Eurotex Knitwear Ltd

Nayamati, Kutubpur, Fatullah, Narayanganj, Bangladesh
(23.64885N,90.5021E)

02 April 2014

Observations

Inconsistencies between structural drawings and the as-constructed arrangement of the factory

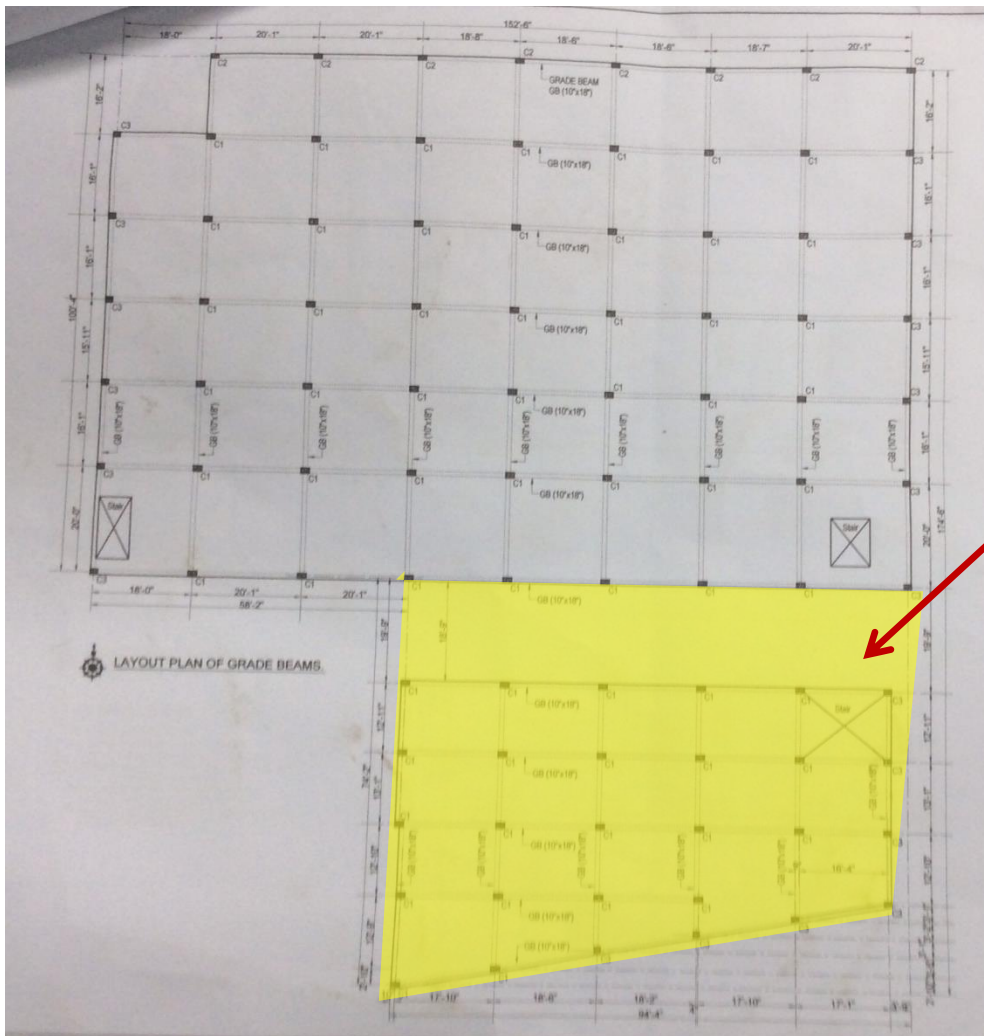
Column sizes measured in this highlighted area are smaller than the size noted on the construction drawings

Building Engineer to survey as-built structure and update drawings including verification of column sizes.
